## Safety Notice

<b>Affected Models</b>	MV800 units with T14MV trailer, see attached list for serial numbers
<b>Attention</b>	Dealership Owners, Managers, Parts and Service Managers
<b>Description</b>	Please see the attached customer notice.
<b>Parts Required</b>	N/A
<b>Estimated Repair Time</b>	30 minutes
<b>Compensation</b>	parts/labor/mileage
<b>Dealership Notes</b>	<p>URGENT: Please perform this update as soon as possible in the interest of safety. Ditch Witch requests that you update all machines in your area by January 31, 2016.</p> <p>A notification will be mailed to owners of affected models in one week. A list of units in your area is included. Please note "What You Should Do" section of the attached customer notice. If you have any questions, contact the Trenchless Product Support Group.</p>

inmv800004s.jpg

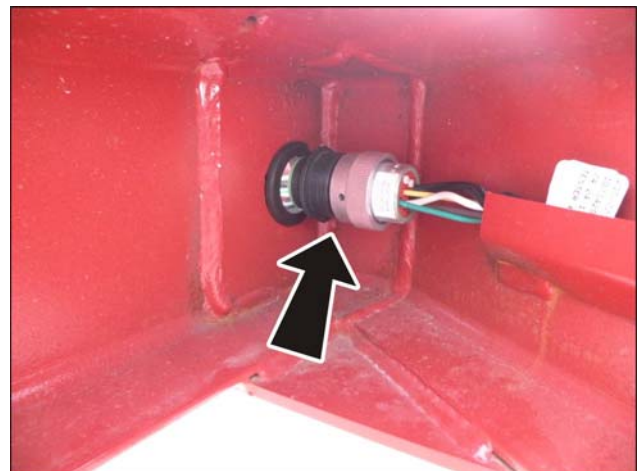
- Use yellow tool (259-439) to move black/white wire from pin F to pin H (shown).
